**PURPOSE STATEMENT**  
FOR REVISION #5  
THE PURPOSE OF THIS REDLINE IS TO ADD 13,29'x40' BATHROOM EXPANSION TO THE EX. COMMUNITY BUILDING, HANDICAP SPACE, CONCRETE STOOP AND REVISE THE STORMWATER MANAGEMENT FACILITY.

**PURPOSE STATEMENT**  
FOR REVISION #6  
THE PURPOSE OF THIS REDLINE IS TO REPLACE THE EXISTING POOL DECK (TRAINING POOL, ADD STORMWATER FACILITIES & DETAILS.

**PROJECT TITLE:** LOUGHELOW NEIGHBORHOOD CENTER 5TH ELECTION DISTRICT, HOWARD COUNTY  
SUBJECT: M 29 2731, LOT 1, 2, 3

**AS-BUILT SITE PLAN**

SWM As Built SUPPLEMENTAL SHEET  
**REVISED STORMWATER MANAGEMENT PLAN**  
LONGFELLOW NEIGHBORHOOD CENTER  
OPEN SPACE LOT 2, SECTION 1, AREA 5  
TAX MAP: 29 PARCEL: 273 15th ELECTION DISTRICT ZONE: N.T.  
HOWARD COUNTY, MARYLAND  
SHEET 6 OF 11

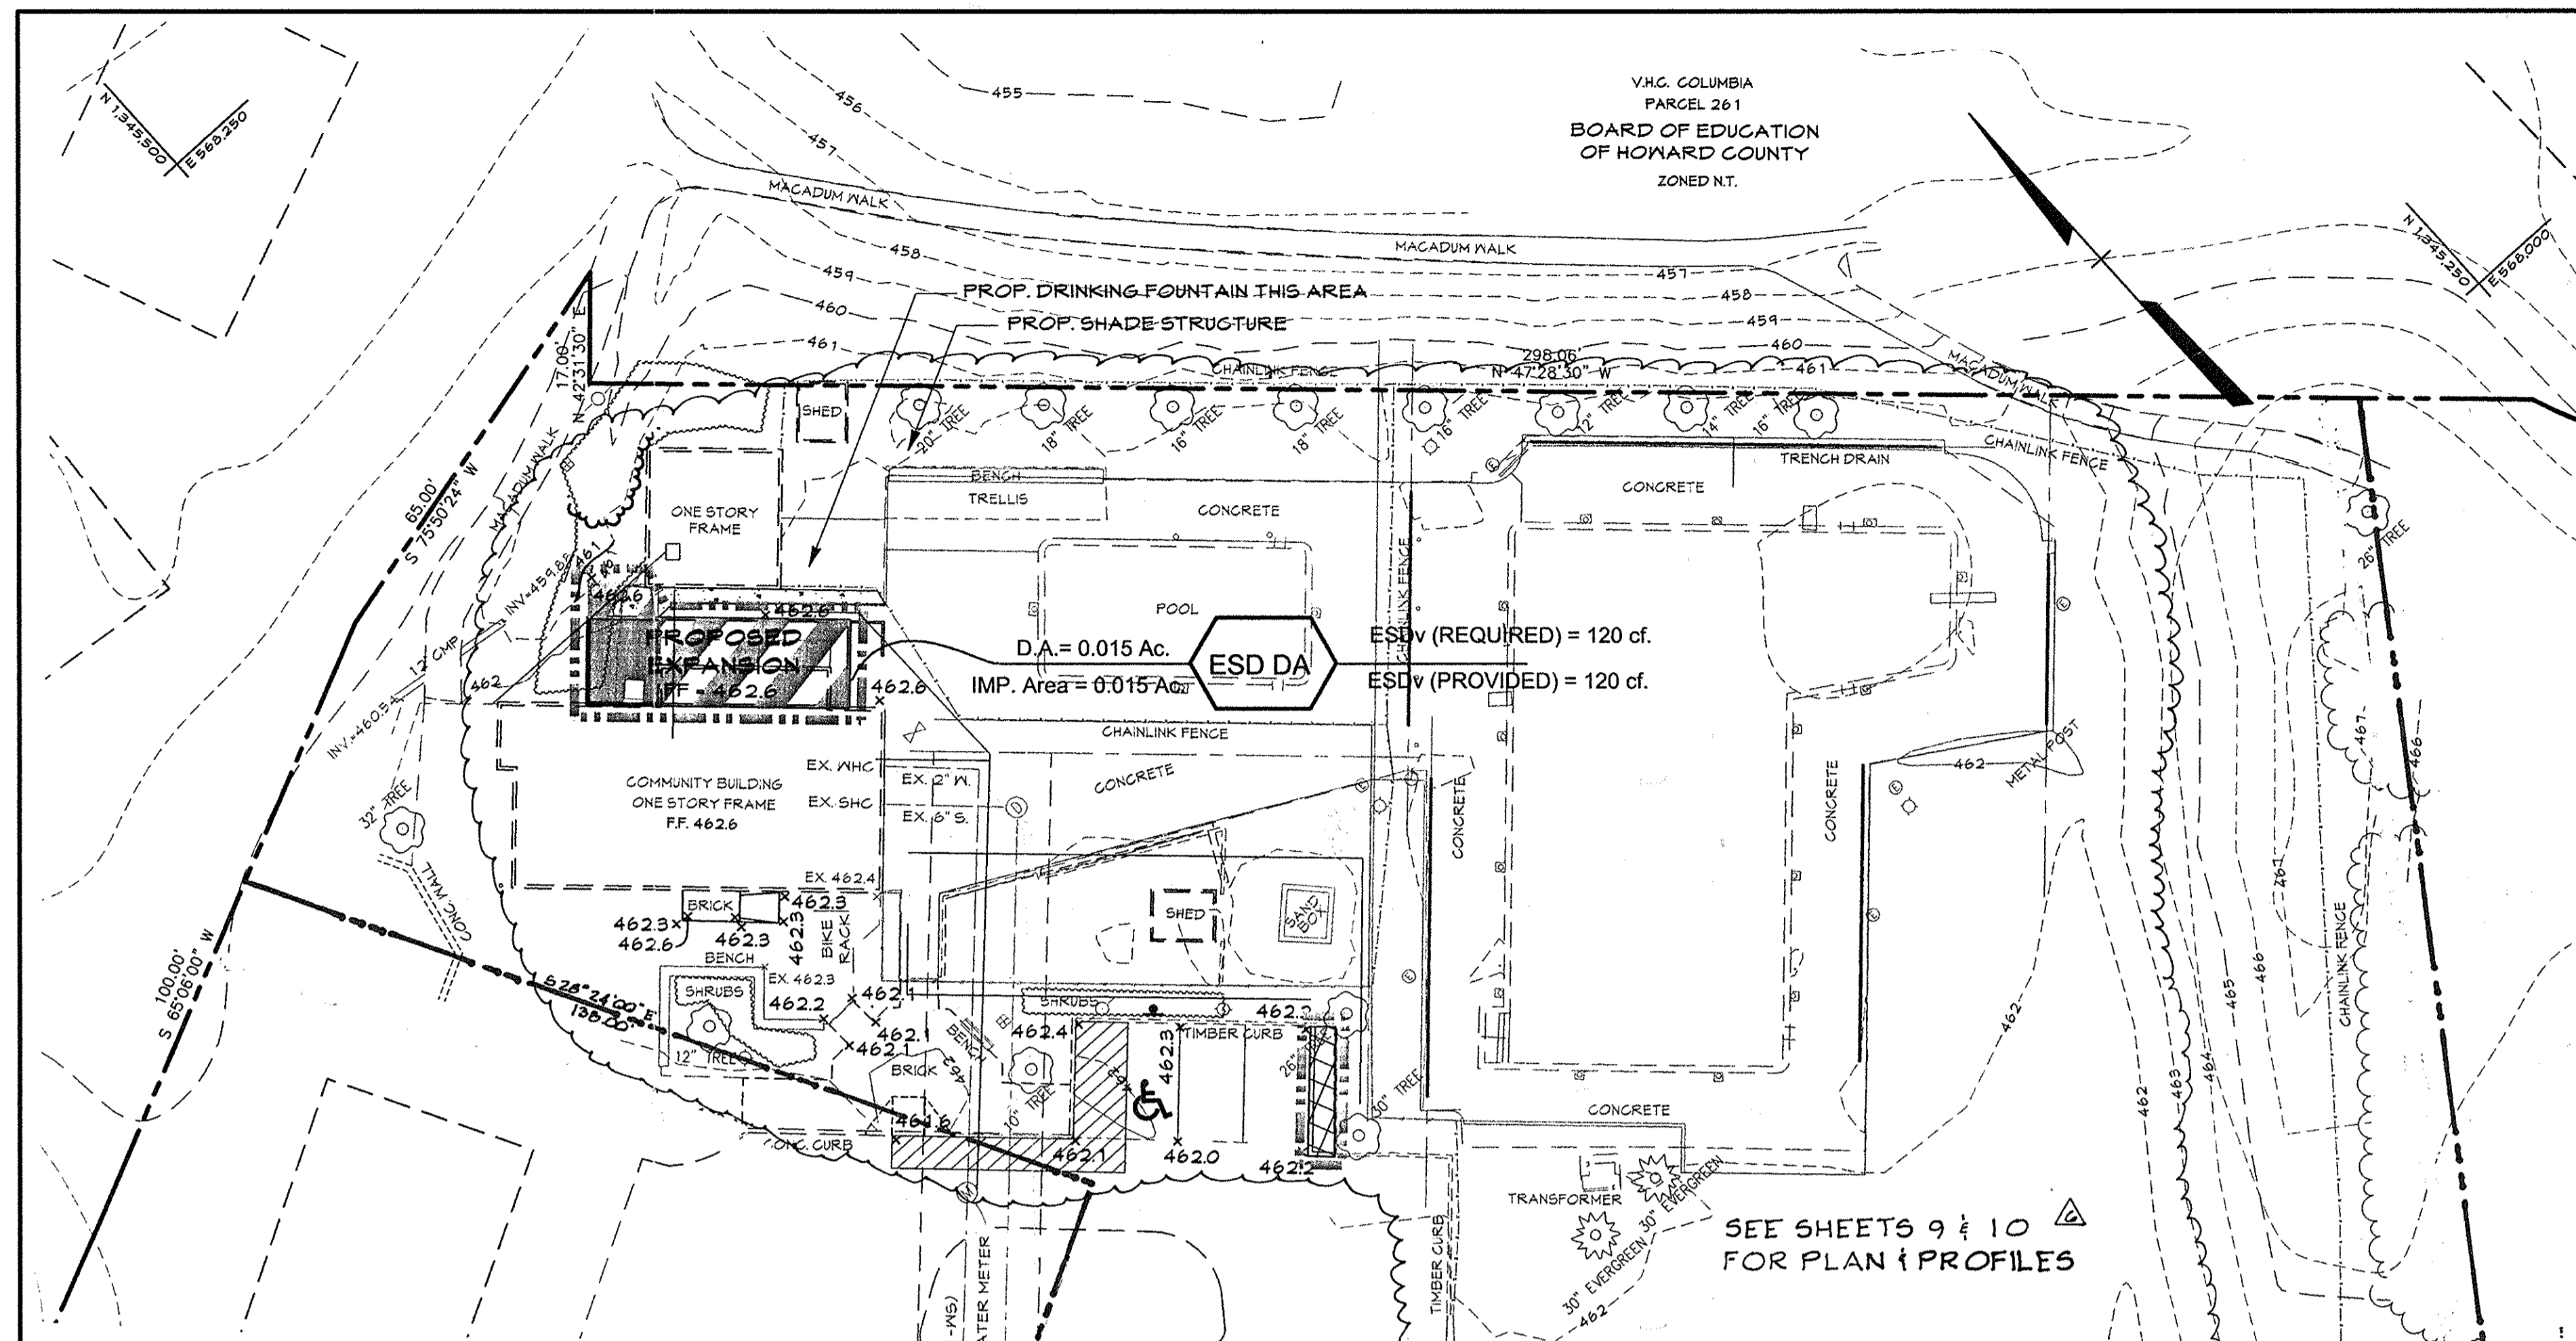
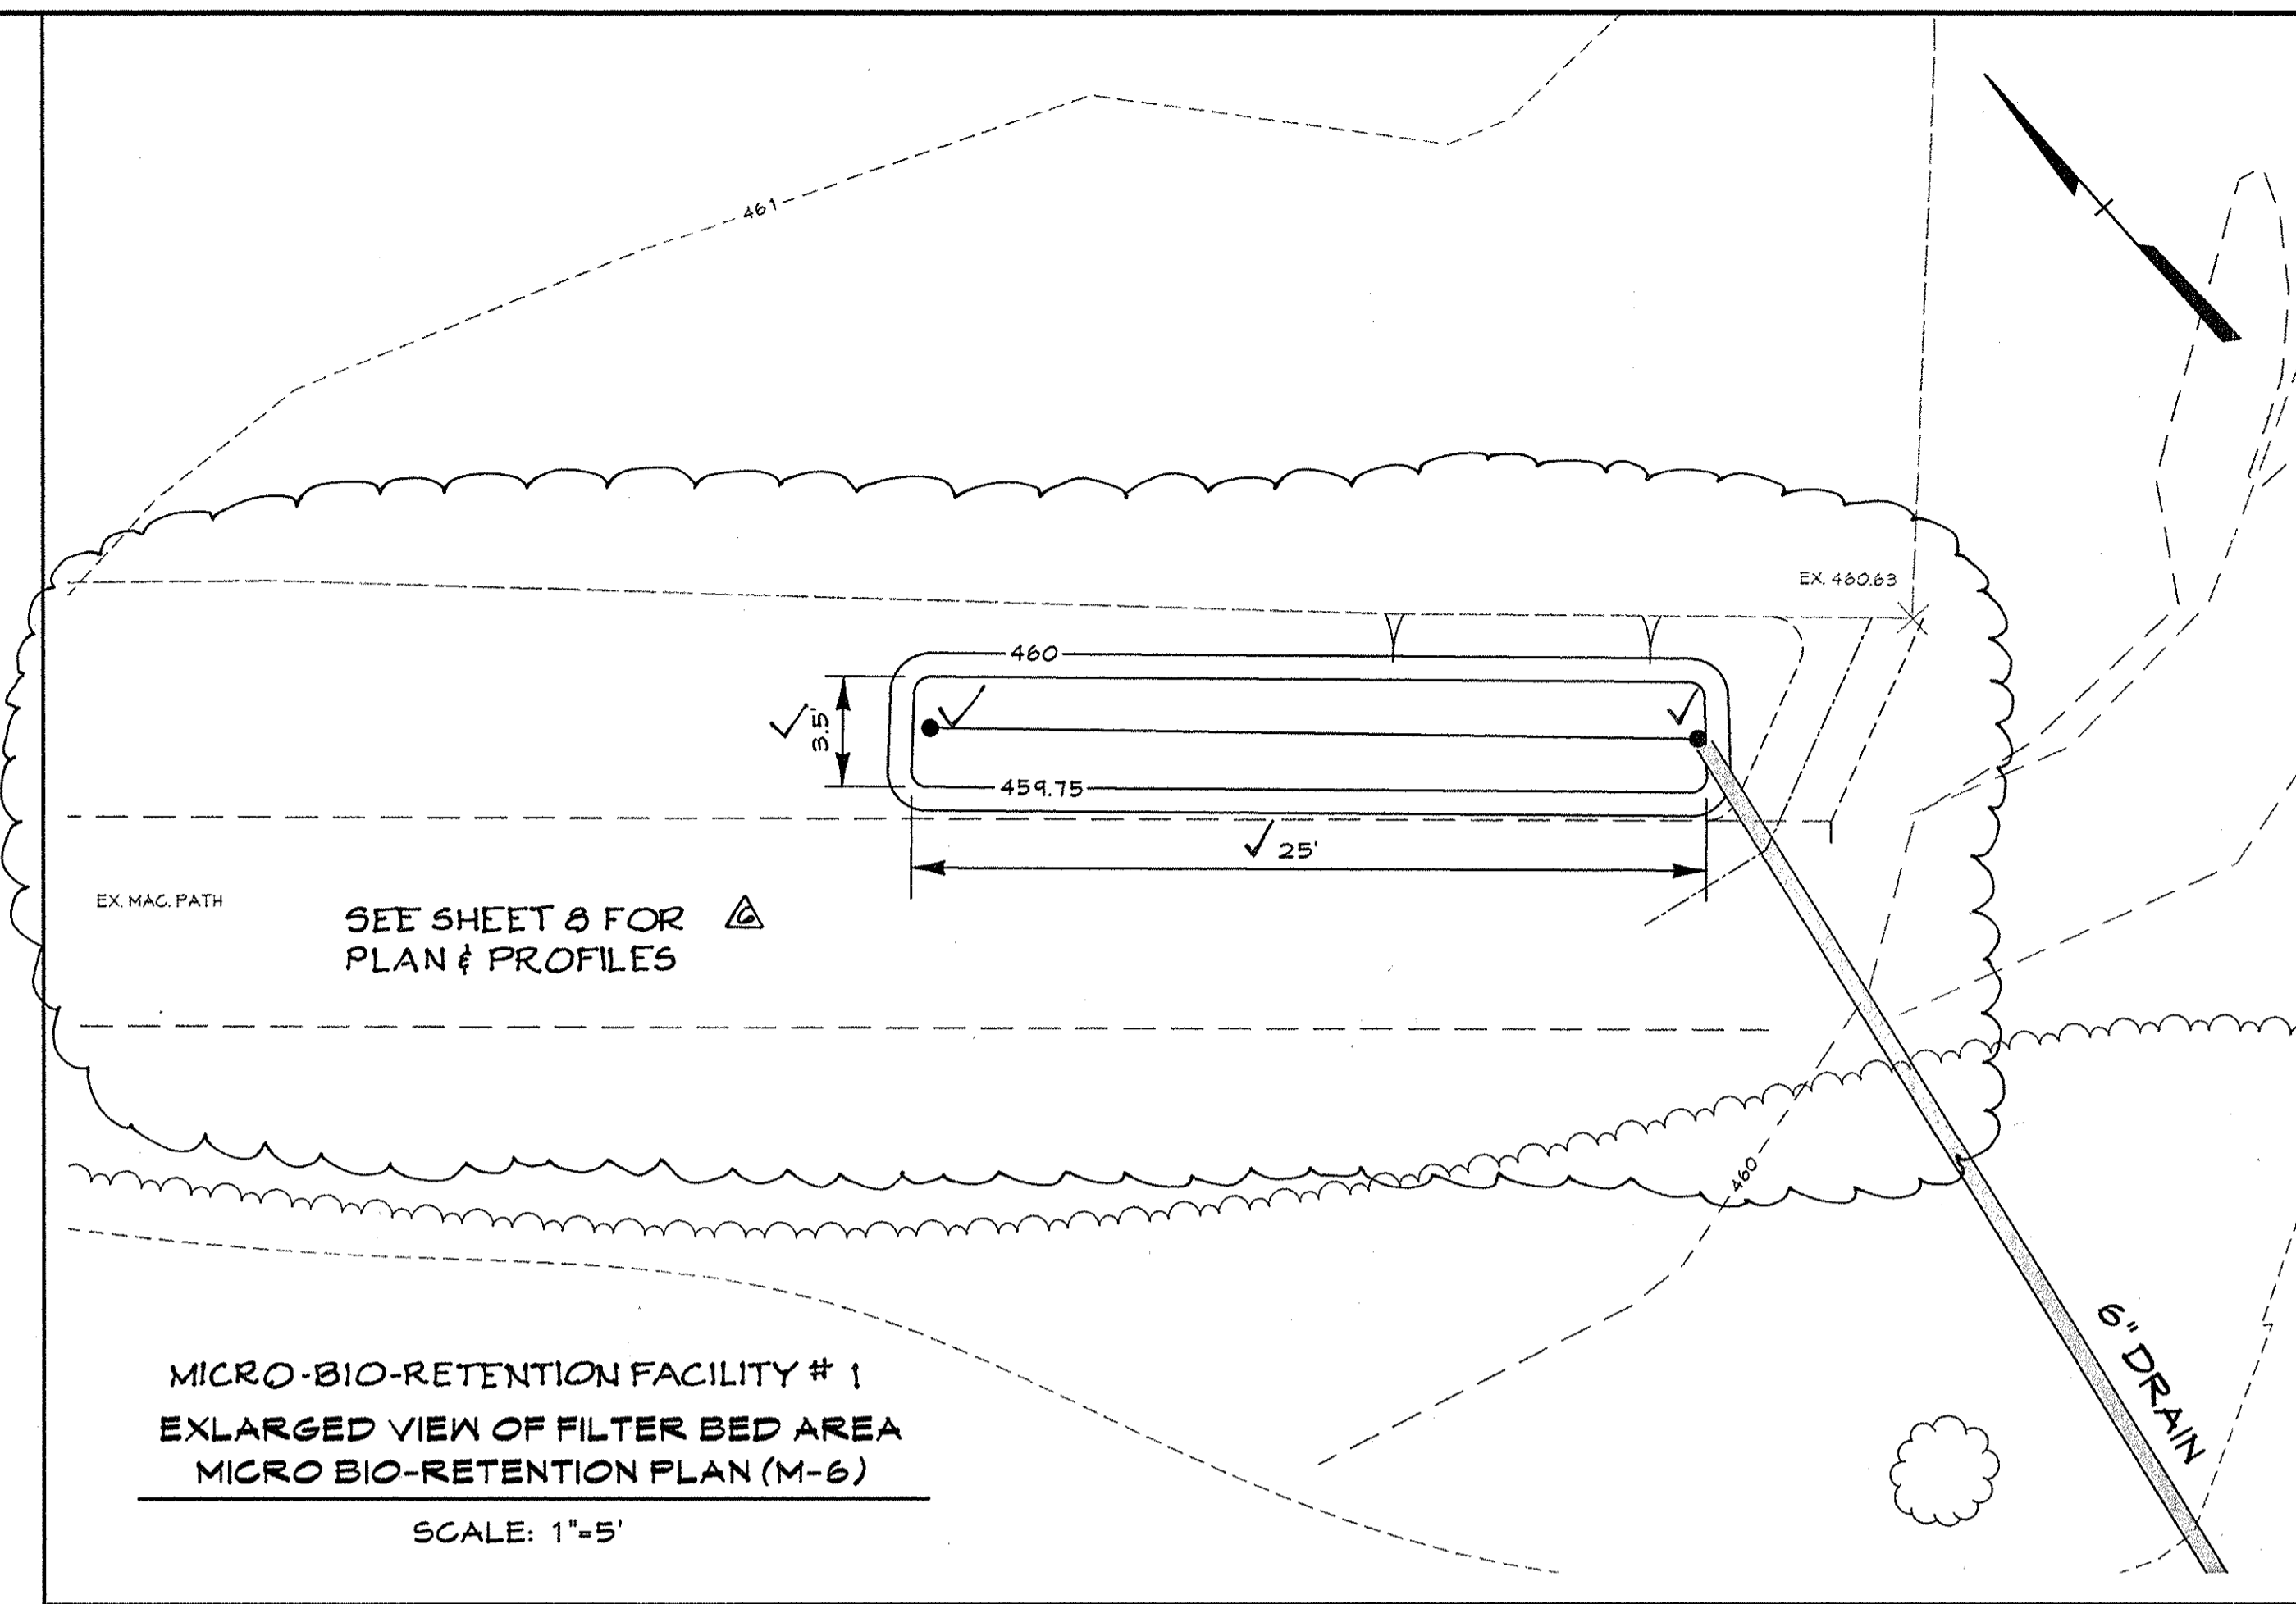
**PURPOSE STATEMENT FOR REVISION #6**  
THE PURPOSE OF THIS REDLINE IS TO REPLACE THE EXISTING POOL DECK & TRAINING POOL. ADD STORMWATER FACILITIES & DETAILS

THE PURPOSE OF THIS REDLINE IS TO ADD 13.29' x 40' BATHROOM EXPANSION TO THE COMMUNITY BUILDING, CONCRETE STOOP, STORMWATER MANAGEMENT FACILITY, AND REVISE THE EXISTING HANDICAP PARKING SPACE.
